**Project #18-033
Niederhauser Retail
Located at 730 South Main**

Project Name: Niderhauser Retail
Proponent/Owner: Mike Medina / Geraldine Niederhauser
Project Address: 730 South Main Street
Request: Design Review Permit
Current Zoning: Commercial (COM)
Date of Hearing: September 27, 2018
Type of Action: Quasi-Judicial
Submitted By: Russ Holley, Senior Planner

Staff recommends that the Planning Commission **approve** a Design Review Permit for Project #18-033 Niederhauser Retail, for a 4,800 SF multi-tenant commercial building located at approximately 730 South Main Street; TIN #02-065-0011.

1 SITE PLAN
1/16" = 1'-0"

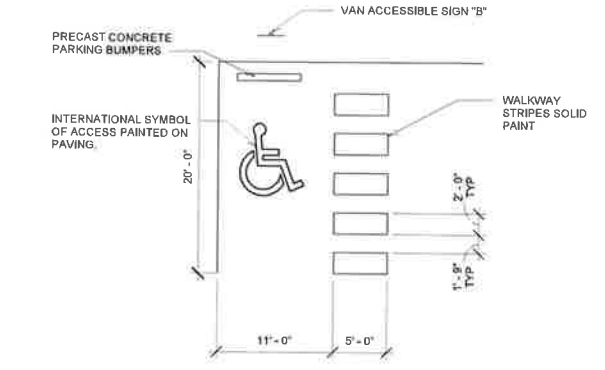
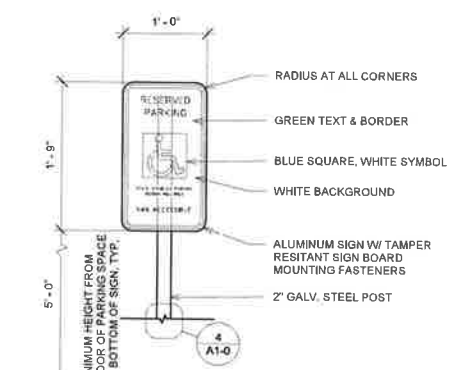
1. All standard conditions of approval will be recorded with the Design Review and are available in the Community Development Department.
2. The building shall have 30% transparency, which could include spandrel windows, on the west façade and have similar architectural features, articulation and details that are found on the east façade containing the primary entrance.

3. The sidewalk connecting the building to Main Street along the north property line shall have curb cuts and paint delineation across the drive thru aisle.

4. All public pedestrian entrances shall have weather protection provided above.
5. A minimum of 22 parking stalls, 8 stacking positions within the drive-thru isle and a bike rack shall all be provided.

- b) Open Space and Useable Outdoor areas shall total a minimum of 7,753 SF.
 - c) A total number 17 trees and 44 shrubs, perennials and grasses shall be provided. 25% of the trees shall be evergreen.

- d) The drive-thru shall be buffered and screened from Main Street with shrubs and flowers.
8. All dumpsters shall be visually screened or buffered from public streets by using fencing, walls and landscaping.

A NEW FACILITY FOR:
COSTA VIDA & JERSEY MIKE'S
 790 SOUTH MAIN STREET LOGAN, UTAH
EXTERIOR ELEVATIONS

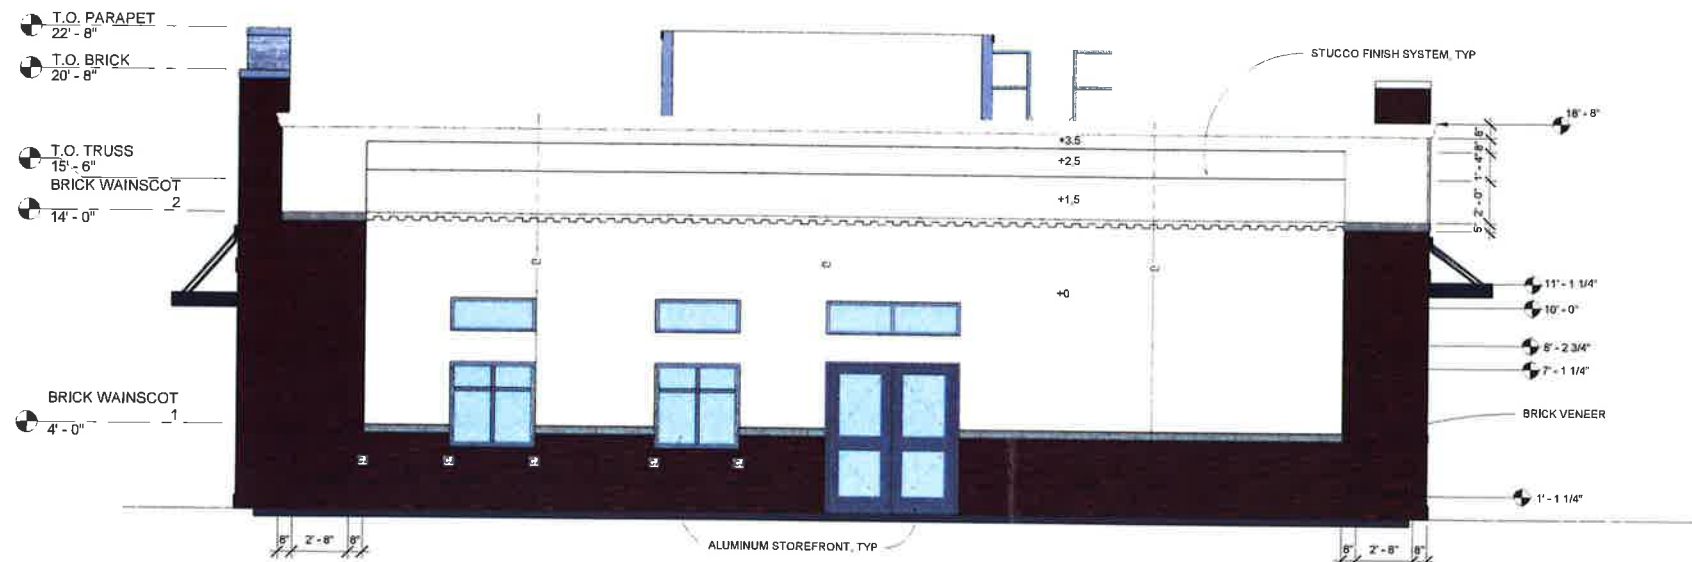
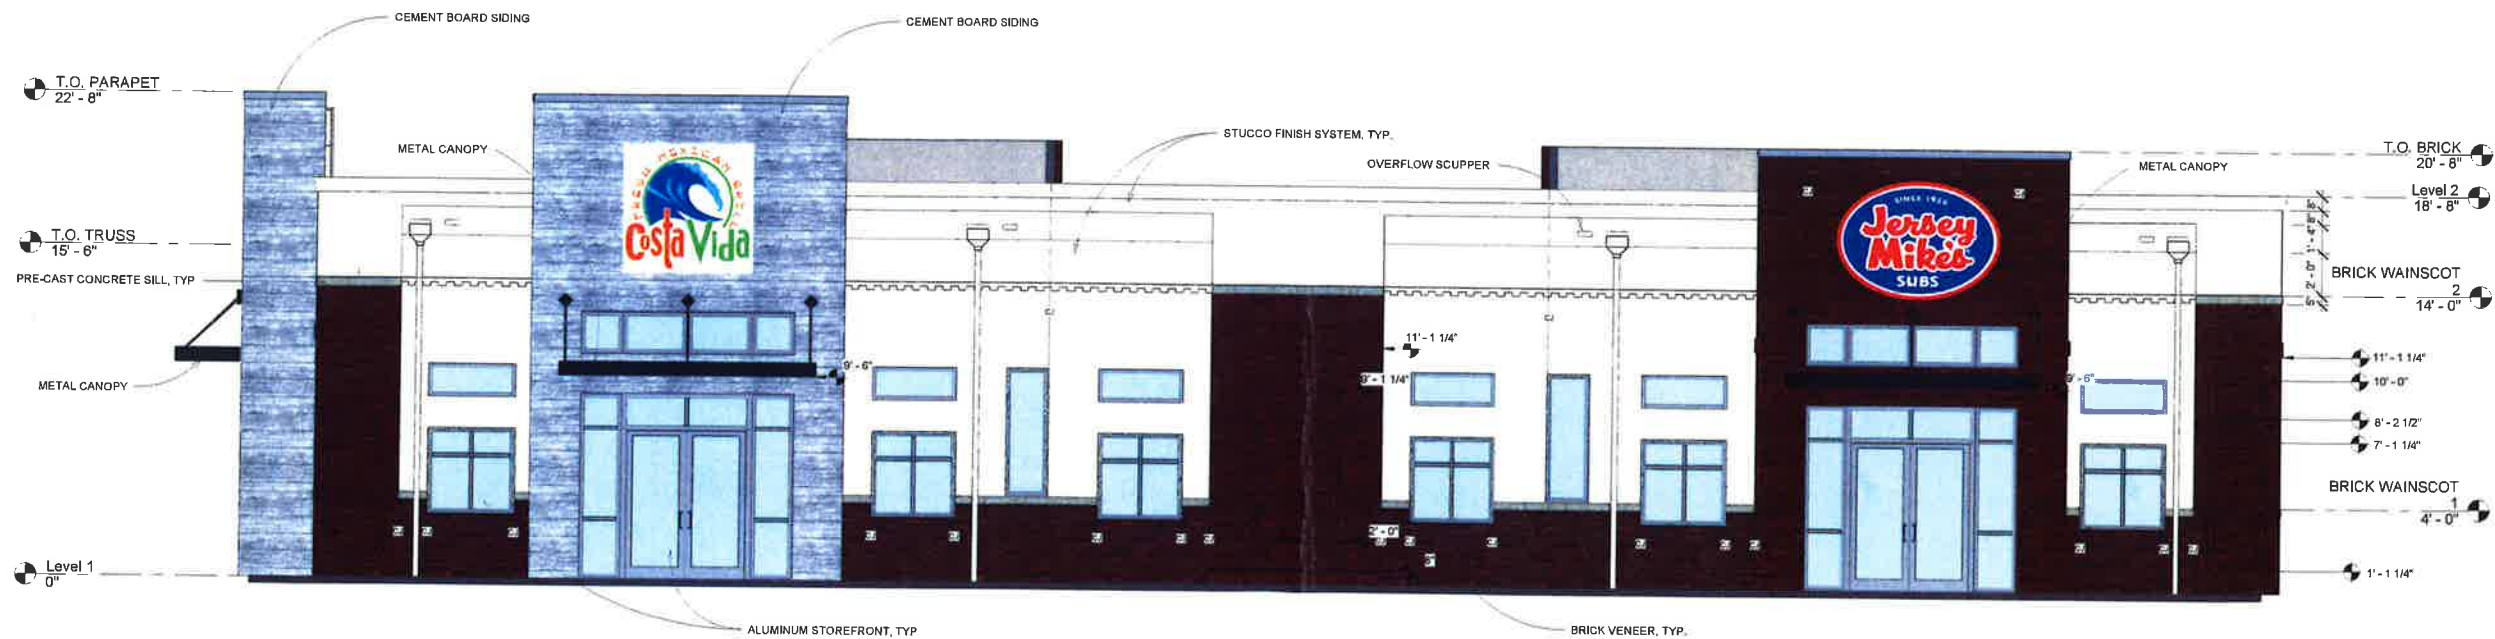
The LDC 17.12.030 states that buildings should generally have primary entrances and front facades facing the adjacent street. In situations where the façade with the primary entrance is not facing the street, then the façade facing the street shall have similar architectural style, features, details and visual interests of the façade that contains the primary entrance. The LDC 17.10.030 requires street facing facades in the COM zone, regardless of the location of the primary entrance, to have 30% transparency (fenestration). The LDC limits blank or featureless walls in the COM zone to no more than 40 linear feet. The proposed building shows the primary entrance and façade oriented east towards the parking lot opposite of Main Street. The façade facing main street does not have similar features and details found on the east (primary) façade. As conditioned with 30% transparency and similar façade features, such as windows, awnings, wall articulation, material mixes, on both the east and west facades, the building design meets LDC standards.
